**The Proposed Broadwater LNG Import Terminal
Update of Synapse Analysis**

January 19, 2007

Response to Draft EIS

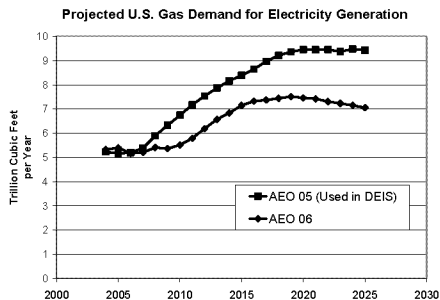
None of these recent events has altered our basic conclusion, that the Broadwater terminal is not required to meet the future energy needs of New York and Connecticut. To the contrary, both of our most basic conclusions have been strengthened. The newer forecasts for gas demand over the next two decades have been revised significantly downward relative to previously available forecasts, largely due to the disappearance of additional gas-fired electricity generation from utility resource plans. This change in projected gas demand for electricity generation is shown in the figure below.
